ADDENDUM NUMBER TWO

BID S-2-22

Subject: **Addendum Number Two to Bid S-2-22 for the LCCC Greenway Underpass Project**

LCCC Greenway Underpass
BID S-22-21
Pre-Bid Meeting, August 17, 2021 at 10:00 AM

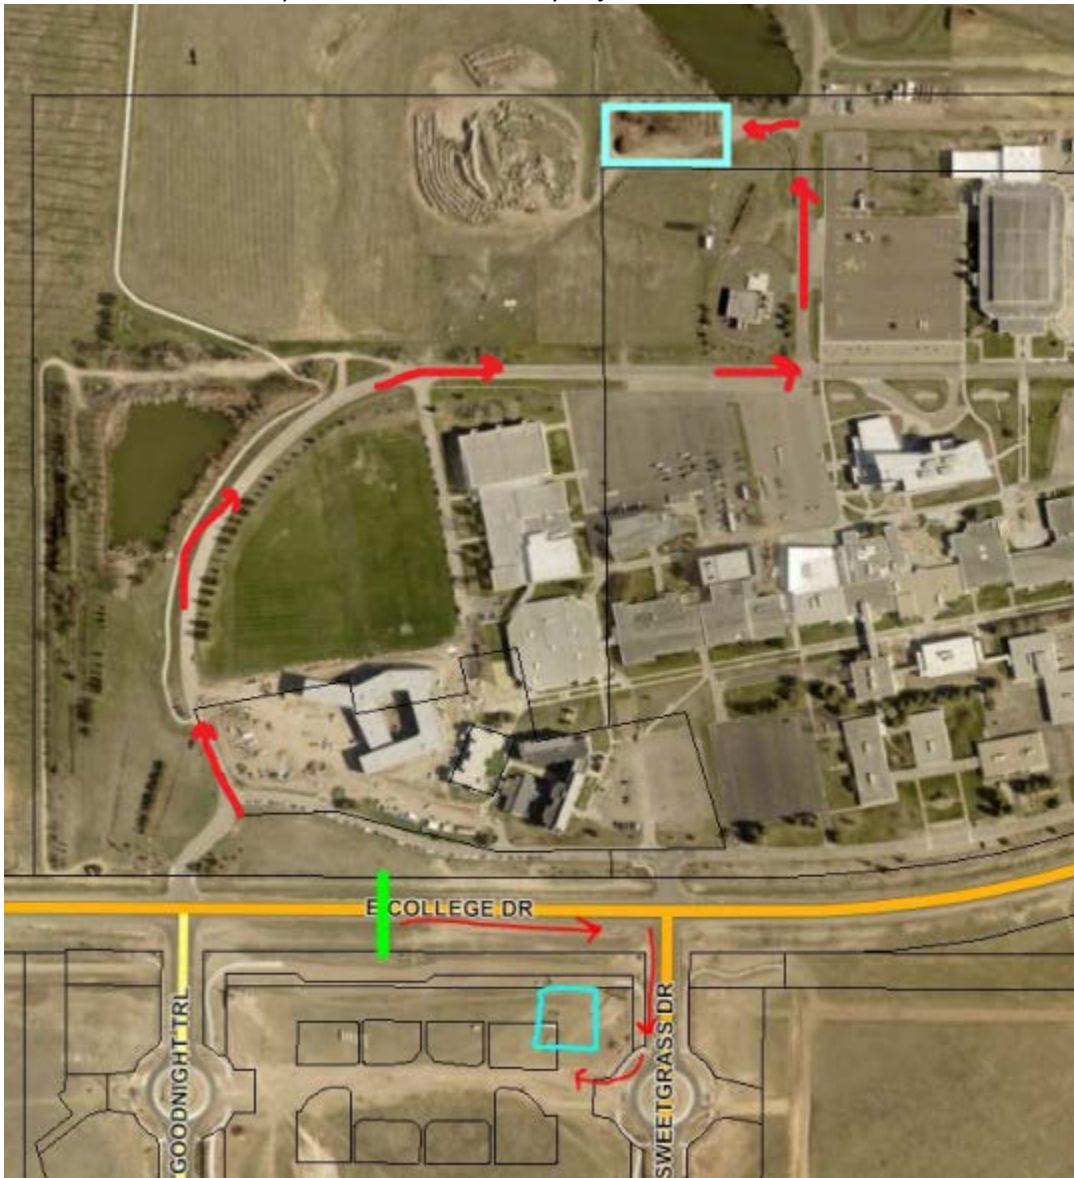
- Wet Utility Construction Notes – groundwater was encountered during the geotechnical investigation on 11-25-2019. We expect to encounter groundwater during construction of the storm sewer that drains the underpass and potentially the retaining walls and RCBC.
- Seeding – The seed mix listed on Sheet S1 has been requested by LCCC. This seed mix must be used on any disturbed area on the north side of College Dr. You can use city standard dryland seed mix on the south side of College if you wish (City Spec 02900).

- **Unclassified Excavation**
 - Contractor can dispose of excess unclassified excavation in Sweetgrass Village Center (south side of College Dr.) and at the LCCC storage site north of the campus buildings/west of the arena.

- Sweetgrass Village Center: contractor shall strip 3" of topsoil from the disposal area for the size he will need and place topsoil in a stockpile. Place unclassified excavation in wind rows. Enter and exit Village Center from the west leg of the Sweetgrass Dr. roundabout. This is all paid as Unclassified Excavation, topsoil striping and hauling of unclassified excavation is included in the bid price.

- LCCC: contractor shall place material in the area indicated, windrows or a single pile will be fine. Reminder that this is an active campus so contractor needs to use care when using the haul route and any on-site LCCC roadways. The students won't likely be paying attention and the underpass site is immediately adjacent to the residence halls.
